CITY OF FORT LAUDERDALE

CASE COMMENT REPORT

CASE NO. UDP-S25023

CASE	UDP-S25023
PROJECT NAME	BHMC Surface Parking Lot
APPLICATION TYPE	Site Plan Level II
APPROVAL LEVEL	DRC
REQUEST	Surface Parking Lot in South Regional Activity Center
APPLICANT	North Broward Hospital District
AGENT	Stephanie J. Toothaker, Esq.
PROPERTY ADDRESS	1527 SW 1 st Avenue
ABBREVIATED LEGAL DESCRIPTION	Croissant Park 4-28 B Lots 9 Thru 18, Blk 36 Tog with portion of vacated Flagler Ave, as Desc In OR 39206/169, Lying W of & Adj to said Lots 9 Thru 14
ZONING DISTRICT	South Regional Activity Center-South Andrews west District (SRAC-Saw)
LAND USE	South Regional Activity Center
COMMISSION DISTRICT	4 – Ben Sorensen
NEIGHBORHOOD ASSOCIATION	Poinciana Park Civic Association
SUBMITTED	June 4, 2025
COMPLETENESS ISSUED	June 16, 2025
EXPIRATION	October 14, 2025 (120 Days)
WAIVER	N/A
CASE PLANNER	Nancy Garcia, Urban Planner II

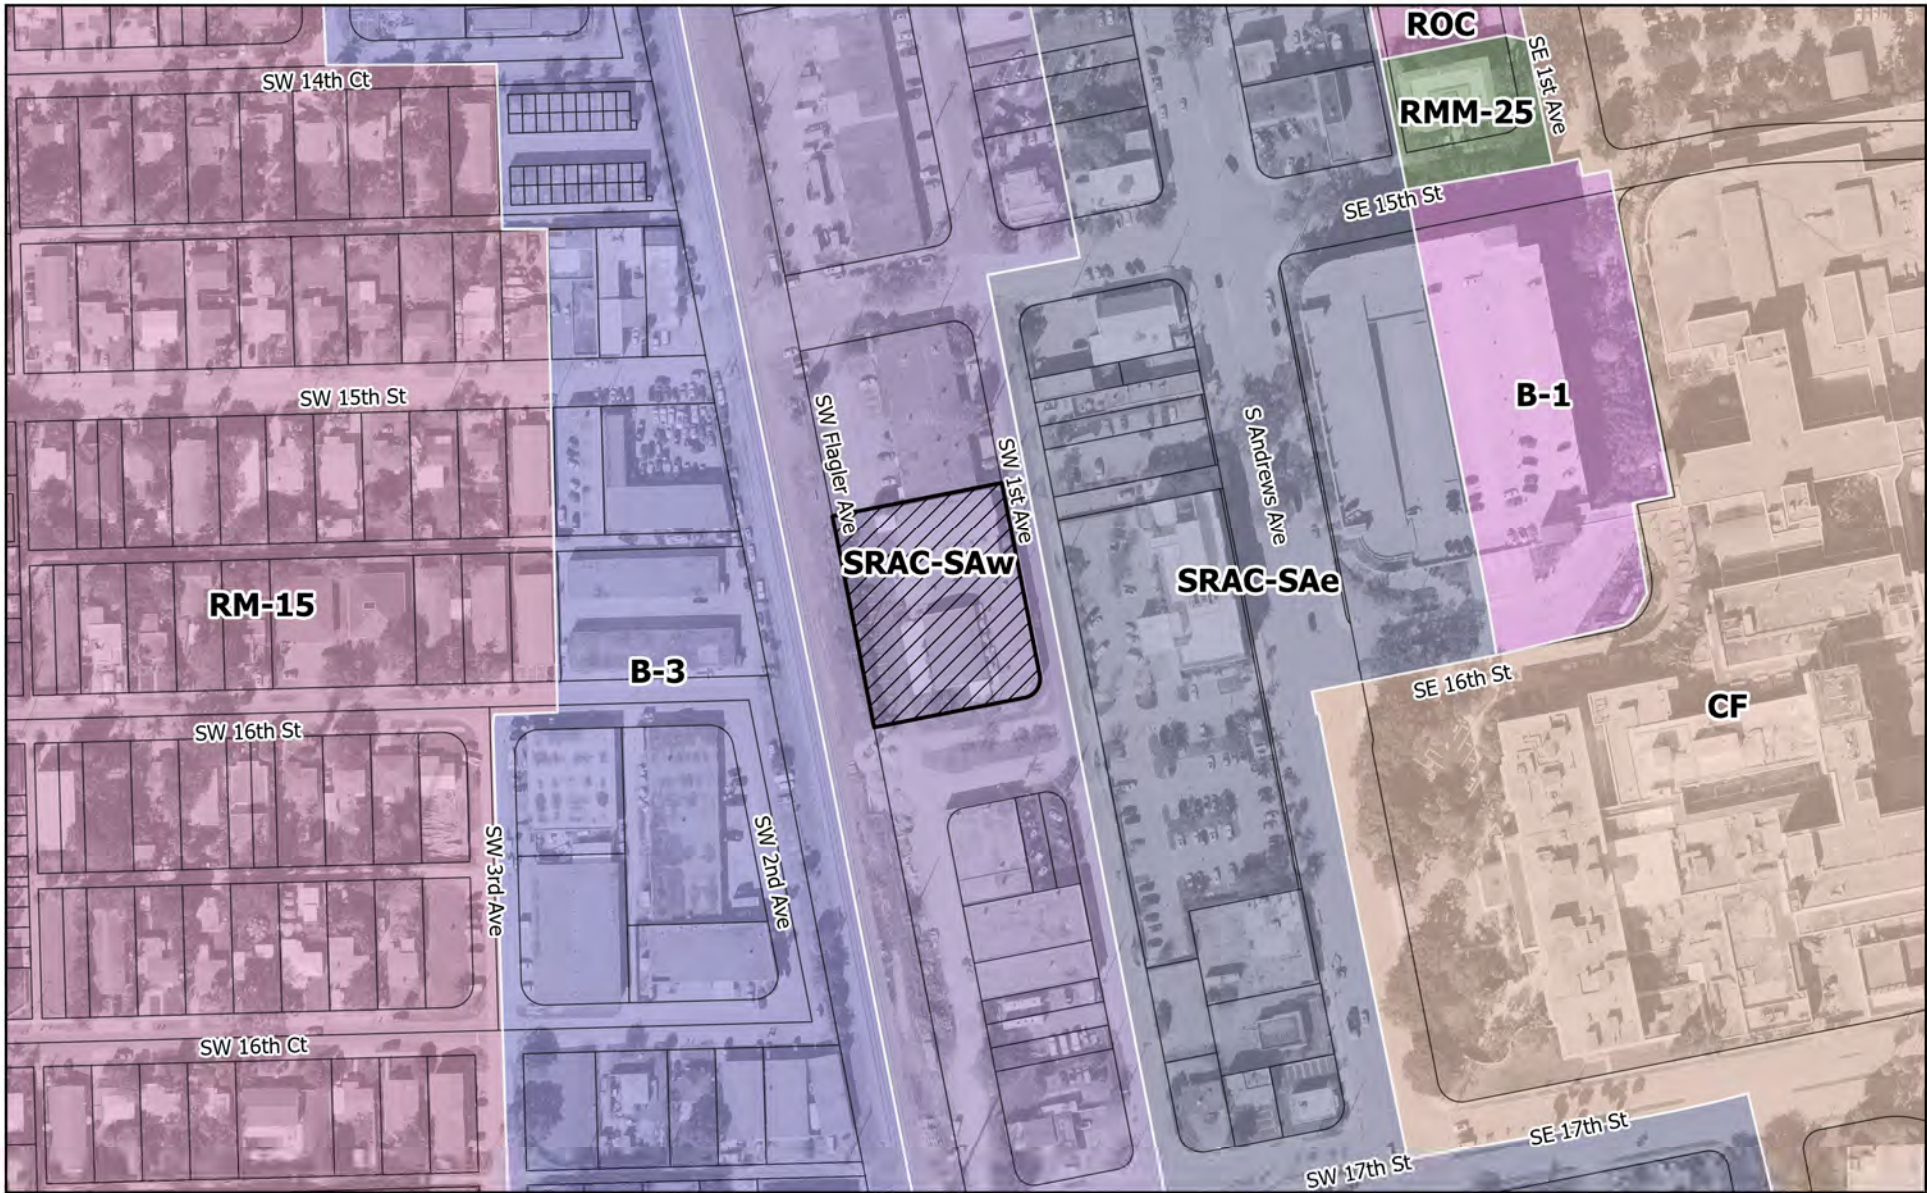
9. Provide a pedestrian crosswalk across SW 1st Avenue.
10. Provide bicycle racks as part of this development. Preferred locations would be along SW 1st Avenue and SW 16th Street.
11. Access to the 24-foot access easement (O.R 39206, PG 169 & OR 40606, PG 1167) cannot be blocked. Revise the portion of the easement along SW 16th Street accordingly. See screenshot from Sheet C-0:
